Access Compliance Report

Public Rights-of-Way

Intersection ID: 45245	Main Street: KODIAK_CT	Cross Street: BRIGHTFALLS_WY	Location: W
ADA ID: 4671629138AC	Ramp Type: PerpDiag	Initial Pass/Fail: Fail	Overall Compliance: No
		Severity Score: 42.5

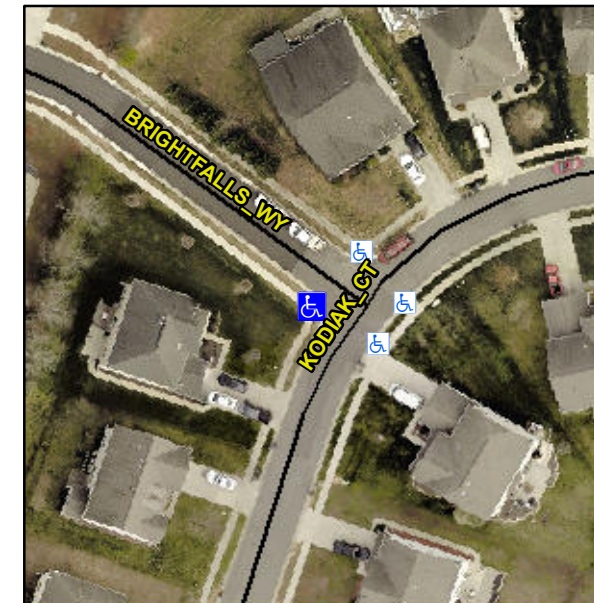
Not Found, R304.5.1, R304.5.3

Compliance	Description	Data	Compliance	Description	Data
N/A	Ramp Length (in)	48.0	Yes	Ramp Slope (%)	6.0
No	Ramp Width (in)	34.5	No	Ramp XSlope (%)	7.2
N/A	Flare Type LT	N/A	N/A	Flare Type RT	N/A
N/A	Flare Slope LT (%)	N/A	N/A	Flare Slope RT (%)	N/A
N/A	Flare Traversable LT?	N/A	N/A	Flare Traversable RT?	N/A
N/A	Landing Length (in)	N/A	N/A	DWS Provided?	N/A
N/A	Landing Width (in)	N/A	N/A	DWS Contrast?	N/A
N/A	Landing Slope (%)	N/A	N/A	DWS Length (in)	N/A
N/A	Landing X Slope (%)	N/A	N/A	DWS Full Width?	N/A
N/A	Landing Curb? (Y/N)	N/A	N/A	DWS Offset (in)	N/A
N/A	Shared Landing?	N/A			
N/A	Gutter Ponding?	N/A	N/A	Gutter Slope (%)	N/A
N/A	Gutter Lip Ht (in)	N/A	N/A	Gutter X Slope (%)	N/A
N/A	Painted X Walk1?	No	N/A	Painted X Walk2?	No
	X Walk 1 Direction	To SW		X Walk 2 Direction	To NE
N/A	X Walk 1 Width (in)	N/A	N/A	X Walk 2 Width (in)	N/A
	X Walk 1 Slope (%)	4.4		X Walk 2 Slope (%)	4.1
	X Walk 1 X Slope (%)	4.6		X Walk 2 X Slope (%)	1.1

Remove & Replace Curb Ramp With Two New Directional Ramps or Equivalent.
